SERVICE ACTION RECALL		
To: All Dealers / MEAM For the attention of: The Dealer Principal Please copy to: The Service Manager The Sales Manager The Parts Manager Warranty Administrator Aston Martin Technician(s)	Reference: SAR 011 Issued: November 2005	Page: 1 of 5
Model: DB9		
Vin Range: A04048 - B04296		
Subject: ZF Automatic Transmission -Parking Pawl Glide Plate

These vehicles should therefore be modified and have a new parking pawl glide plate installed into the vehicle at the earliest opportunity. In order to rectify this manufacturing error on DB9, we are issuing Service Action Recall SAR 011.

Figure 1

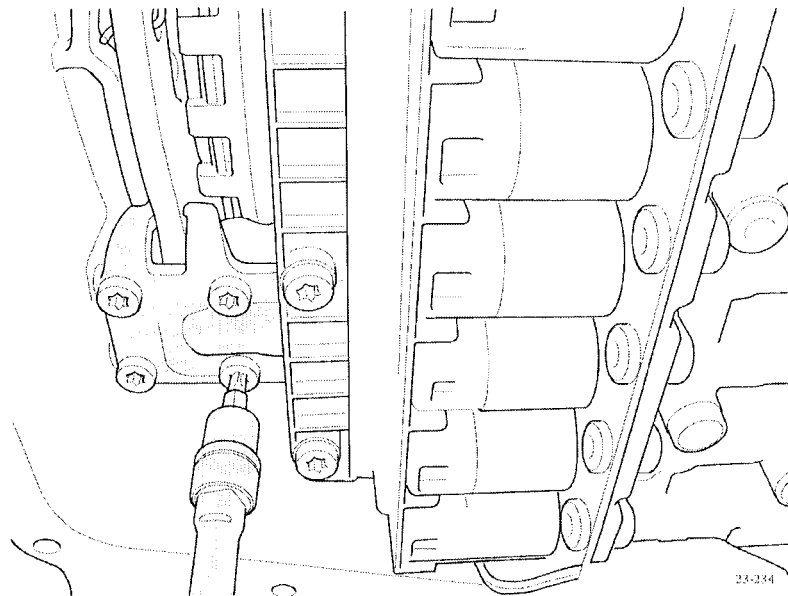
- Remove the rear sub-frame cross-member
- Remove the left-hand rear exhaust pipe
- Disconnect the oil cooler pipes from the gearbox at the thermostat and remove the pipework/thermostat assembly
- Drain the gearbox oil into a clean container for re-use, and refit the drain plug
- Remove the gearbox oil pan
- Locate and remove the Park Pawl Guide Plate by removing the four Torx screws and ease the old plate out of the gearbox, (see figure 1). Retain the displaced part for warranty return

- Fit the new Park Pawl Guide Plate and tighten the four Torx screws to 10Nm
- Check the park pawl is free to move
- Refit the gearbox oil pan, (confirm that the original gasket is clean and fully seated before refitting the gearbox oil pan) and cross torque all screws to 7-9Nm
